10/675,229

Takako Fujii

Office Action Summary

DETAILED ACTION

FIG 2 Annotated

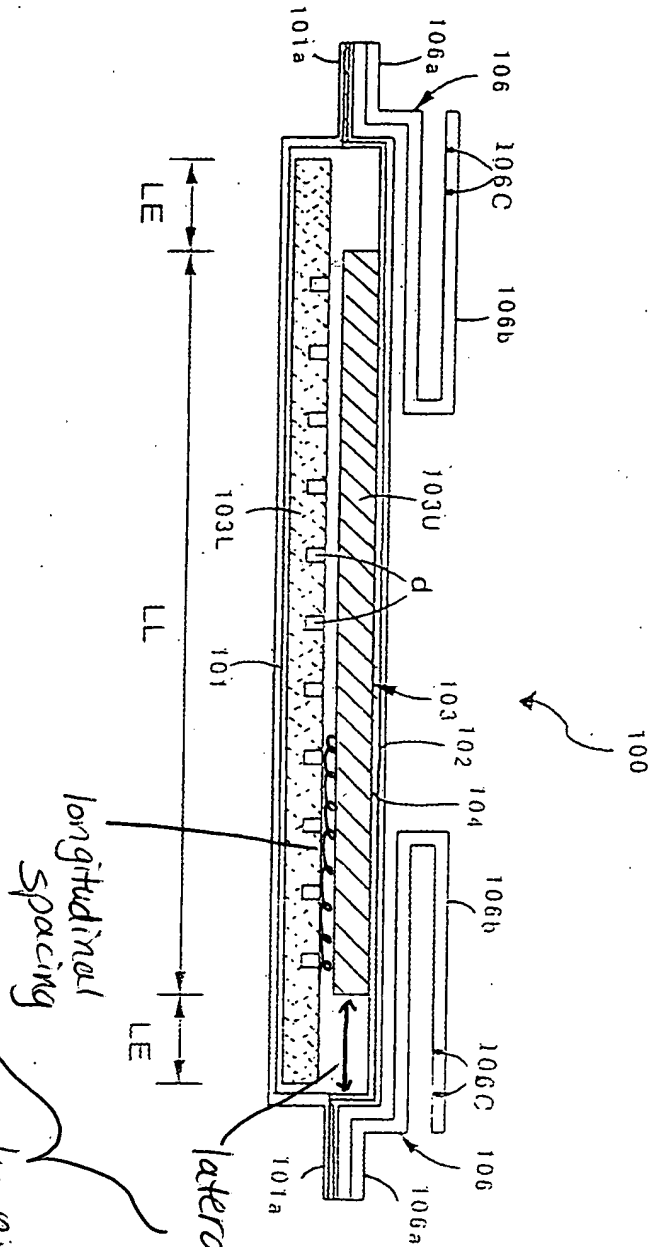
The limitation that "the lower layer extends beyond an outer edge of said upper layer" as recited in line 15 of claim 1 is given its broadest reasonable interpretation consistent with the specification that the lower layer of the absorbent extends in a longitudinal or lateral direction beyond a longitudinal or lateral outer edge of the upper

layer. For example, so long as the upper layer is separate and distinct from the lower edge (e.g.—there is spacing in a longitudinal direction or in a lateral direction between the upper and lower layers), [see also attached annotated figure 2] it meets the claim limitation.

lower layer 103L
"extends beyond an outer
edge of said upper layer"
